VÍRGINIA ELECTRIC AND POWER COMPANY Richmond, Virginia 23261

VIRGINIA ELECTRIC AND POWER COMPANY (DOMINION) NORTH ANNA POWER STATION UNITS 1 AND 2 PROPOSED IMPROVED TECHNICAL SPECIFICATIONS REQUEST FOR ADDITIONAL INFORMATION (RAI) ISTS 3.7.7 BEYOND SCOPE ISSUE (TAC Nos. MB1439 and MB1440)

Proposed Improved Technical Specifications Beyond Scope Issue TAC Nos. MB1439 and MB1440 ITS 3.7.19, "Component Cooling"

North Anna Improved Technical Specifications (ITS) Request for Additional Information Component Cooling Water (CC) System (TAC Nos. MB1439, MB1440)

WOG STS

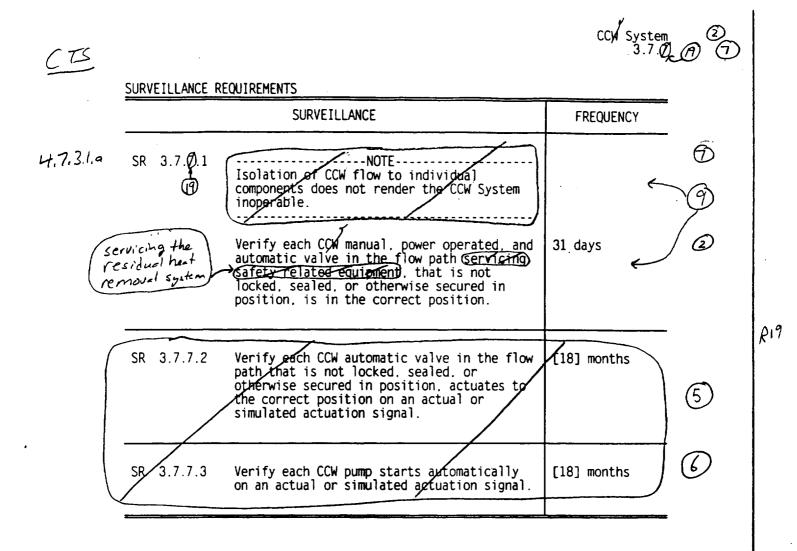
- The CTS requires three of the four CC subsystems to be OPERABLE. The CC System at North Anna does not perform any accident mitigation functions. Its primary safety function is to provide cooling water to the Residual Heat Removal (RHR) heat exchangers and three CC subsystems are required to support a quick cooldown on one unit and normal operating heat loads on the other unit. The ISTS has been changed to reflect the CTS requirements.

- 4. Two new Conditions are added to the ITS, consistent with the CTS. Condition C is added for two CC subsystems inoperable, consistent with the CTS actions. With two required CC subsystems inoperable, normal operating heat loads cannot be removed for two operating units. Cooldown to MODE 4 is necessary to reduce the operating heat loads. In this condition, one or more RHR trains are inoperable. Therefore, it is necessary to initiate and continue actions to cooldown to a MODE in which the LCO is not applicable. Condition C allows 12 hours to reach MODE 4. Action must be initiated within an additional one hour to implement a method of moving the unit out of the MODES of applicability (i.e., to MODE 5) and Actions must continue until the Applicability is exited. Condition D is added for no CC water available to the RHR heat exchangers. With no CC water available to the RHR heat exchangers, the RHR trains are inoperable. Cooldown to MODE 4 is necessary to reduce the operating heat loads. In addition, it is necessary to implement an alternate decay heat removal mechanism and cooldown to MODE 5, in which the LCO is not applicable. These Conditions are consistent with the CTS.

- 5. The CC System does not contain any automatic valves that actuate to perform a function assumed in the safety analysis. Therefore, this Surveillance is not included in the ITS. This change is consistent with the CTS.

- 6. The CC pumps do not actuate to perform a function assumed in the safety analysis. Therefore, this Surveillance is not included in the ITS. This change is consistent with the CTS.

- 7. ISTS 3.7.7 has been renumbered to ITS 3.7.19. An ITS LCO on CC was added after development of the remainder of the ITS. The specification was placed at the end of Section 3.7 to avoid revision to the remainder of the 3.7 specifications.

- 10. ISTS 3.7.7, Required Action A.1 is modified by a Note which directs entry into the applicable Conditions and Required Actions of LCO 3.4.6 for RHR loops made inoperable by CC. This Note does not appear in the ITS. ITS Condition D addresses CC unavailability to the RHR system. This is consistent with the CTS.

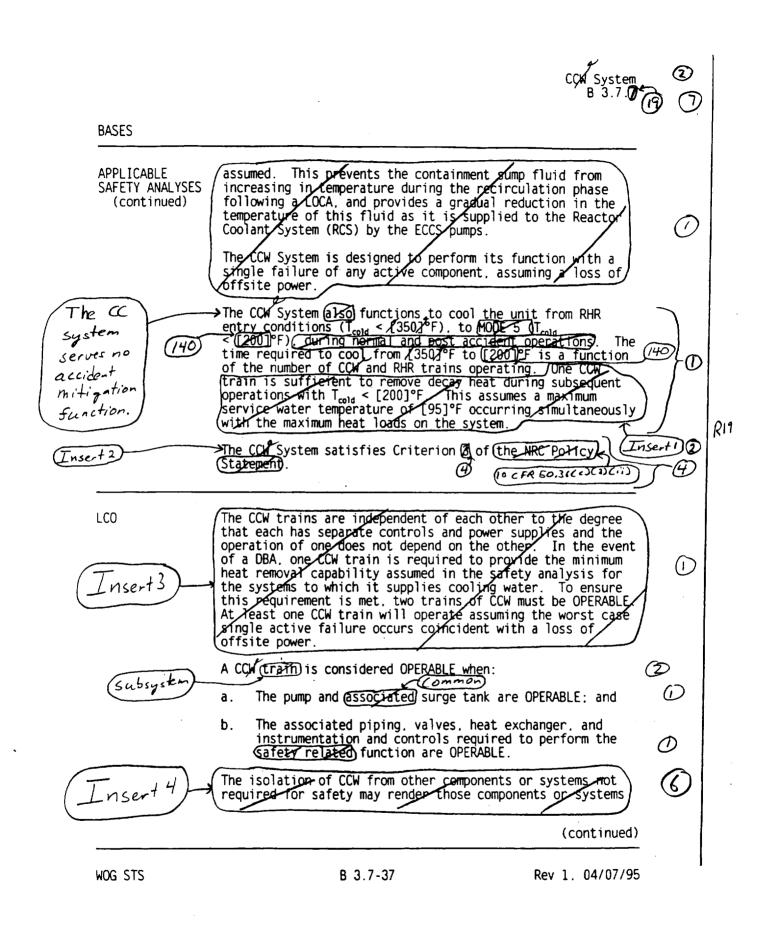
- 1. The CC System at North Anna does not perform any accident mitigation functions. Its primary safety function is to provide cooling water to the Residual Heat Removal (RHR) heat exchangers. Three CC subsystems are required to support a quick cooldown on one unit and normal operating heat loads on the other unit. The ISTS Bases have been changed to reflect the plant-specific licensing and design basis.

- 2. Changes are made (additions, deletions, and/or changes) to the ISTS which reflect the plant specific nomenclature, number, reference, system description, analysis, or licensing basis description.

- 3. The brackets have been removed and the proper plant specific information/value has been provided.
- 4. The CC System at North Anna does not provide any accident mitigation functions. However, the plant-specific probabilistic safety analysis determined that the CC System is significant to public health and safety and the Specification has been retained in the ITS. The criteria of the NRC Final Policy Statement on Technical Specifications Improvements have been included in 10 CFR 50.36(c)(2)(ii). Therefore, references in the ISTS Bases to the NRC Final Policy Statement are revised in the ITS Bases to reference 10 CFR 50.36. The ISTS description that the Specification satisfies Criterion 3 has been changed to specify Criterion 4.

- 6. The Bases are modified to eliminate a statement that the CC system is OPERABLE if CC is isolated from other components. This statement is not applicable to the North Anna design nor is it consistent with the North Anna CTS. See ISTS JFD 9. The following statement is added to the Bases, "Each CC subsystem is considered OPERABLE if it is operating or if it can be placed in service from a standby condition by manually unisolating a standby heat exchanger and / or manually starting a standby pump." This statement is taken from CTS 3.7.3.1, footnote *, and is consistent with the North Anna design.

UNIT 1

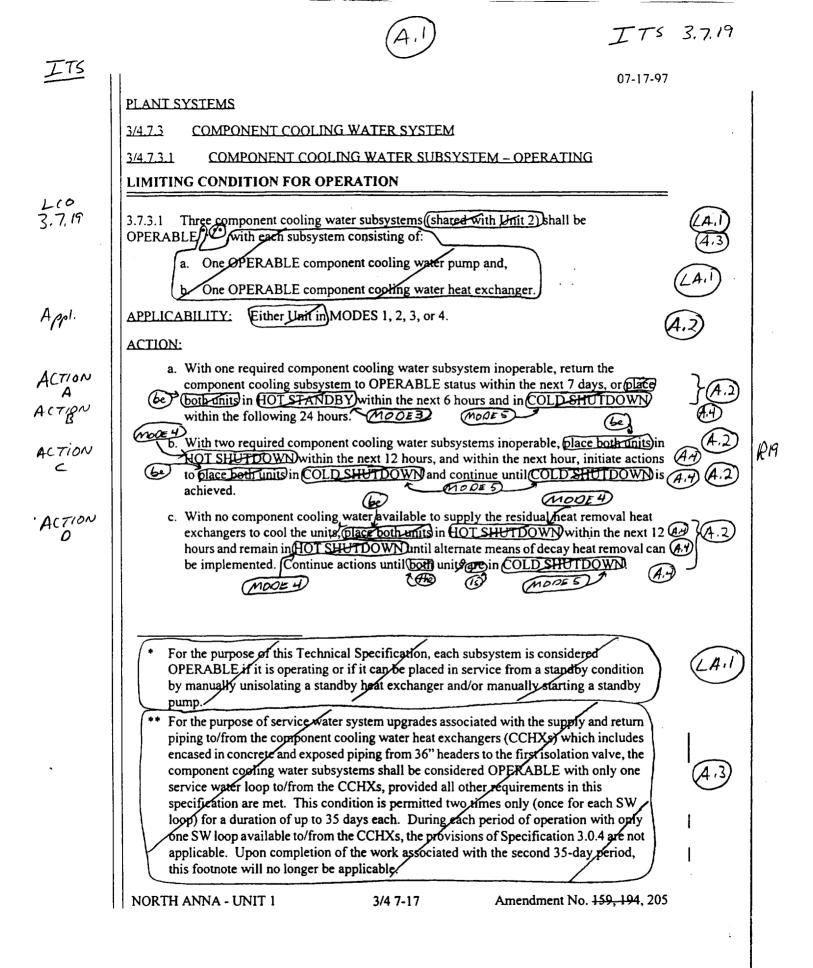
4.7.3.1 COMPONENT COOLING WATER SUBSYSTEM - OPERATING SURVEILLANCE REQUIREMENTS 4.7.3.1 Three component cooling water subsystems shall be demonstrated OPERABLE: a. At least once per 31 days by verifying that each valve (manual, power operated or automatic) servicing in the flow path of the residual beat removal system that is not locked, sealed, or otherwise secured in position, is in its correct position. b. Each component cooling water purposhall be tested in accordance with Specification 4.0.5.	PLANT SYSTEMS	
 ATLANCE REQUIREMENTS A.7.3.1 Three component cooling water subsystems shall be demonstrated OPERABLE: a. At least once per 31 days by verifying that each valve (manual, power operated or automatic) servicing in the flow path of the residual heat removal system that is not locked, sealed, or otherwise secured in position, is in its correct position. b. Each component cooling water pump shall be tested in accordance with Specification 4.0.5. 	14.7.3 COMPONENT COOLING WATER SYSTEM

a. At least once per 31 days by verifying that each valve (manual, power operated or automatic) servicing in the flow path of the residual heat removal system that is not locked, sealed, or otherwise secured in position, is in its correct position. b. Each component cooling water pume shall be tested in accordance with Specification 4.0.5. 	SURVEILLANCE REQUIREMENTS	
automatic) servicing in the flow path of the residual heat removal system that is not locked, sealed, or otherwise secured in position, is in its correct position. • Each component cooling water pump shall be tested in accordance with Specification 4.0.5.	4.7.3.1 Three component cooling water subsystems shall be demonstrated OPERABLE:	
Specification 4.0.5.	automatic) servicing in the flow path of the residual heat removal system that is not	
NORTH ANNA - UNIT 1 3/4 7-17a Amendment No. 159, 194	b. Each component cooling water pump shall be tested in accordance with Specification 4.0.5.	(4,1
